**Request for Additional Information No. 14, Revision 0**

**U. S. EPR Standard Design Certification**

**AREVA NP Inc.**

**SRP Section: 19 - Probabilistic Risk Assessment and Severe Accident Evaluation**

**Figure 19-135-1—Shutdown Events Uncertainty Analysis including HVAC Modeling Uncertainty**

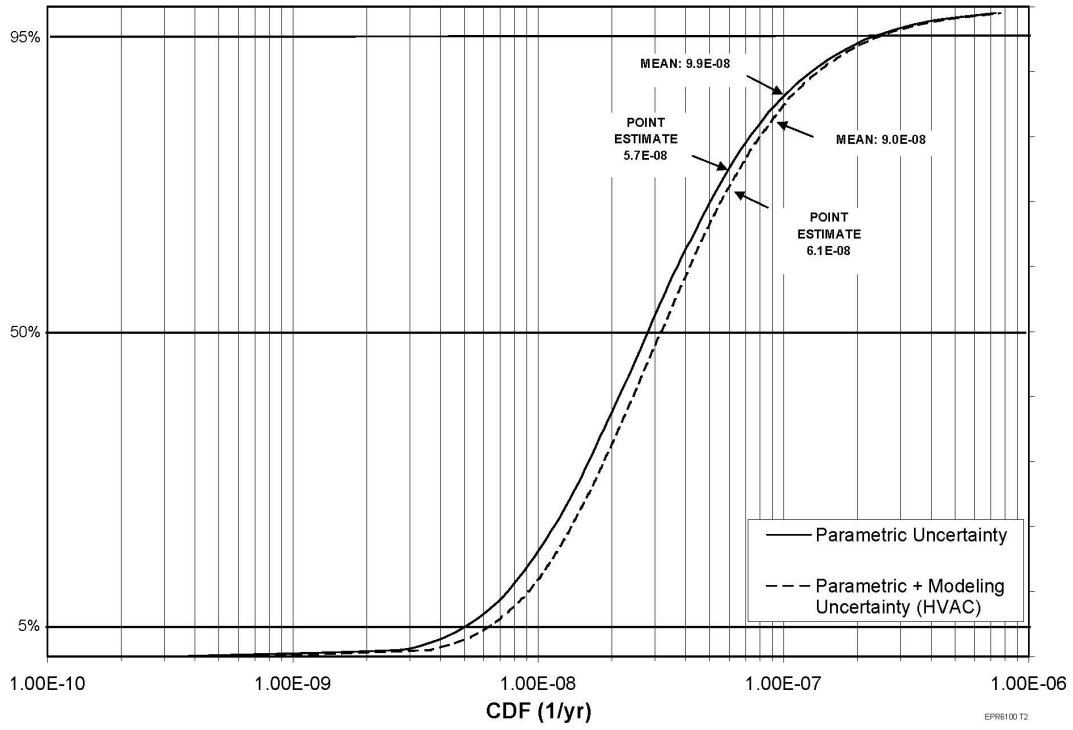
Provide an assessment of the impact on the shutdown PRA results of the HVAC modeling uncertainty case, as described in FSAR Section 19.1.4.1.2.7.

The HVAC modeling uncertainty case in shutdown is illustrated in Figure 19-135-1. The input parameters for this run are defined in the response to RAI 2 Question 19-46 (Case 3). As illustrated in the figure, an inclusion of the HVAC modeling uncertainty results in a core damage frequency (CDF) point estimate/mean value change of less than 10 percent.
